STAFF RECOMMENDATION

CASE FILE NO.: Z0088-19-D

PROPOSAL: Design review of proposed approximately 6,700 square foot building designed to be speculative office and commercial space along with associated site improvements.

Site Plan

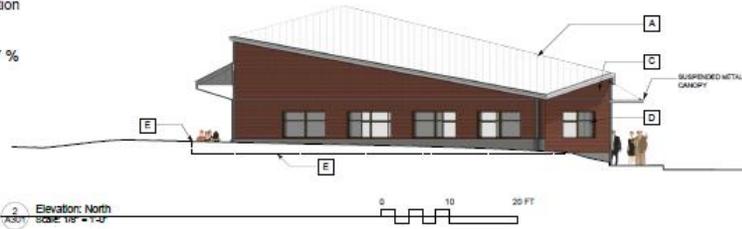
- A. Prior to issuance of building permit, the applicant shall submit revised site drawing showing street trees along the site's frontage on SE Sunnybrook Boulevard and SE 97th Avenue that meet the standards of ZDO 1007.06.

- C. Prior to issuance of building permit, site plan shall be revised to designate an off-street loading zone with dimensions of not less than 35 feet by 12 feet, per ZDO 1015.04.

- D. Prior to issuance of building permit, site plan shall be revised such that the refuse and recycling enclosure meet the dimensional standards of ZDO 1021.05.
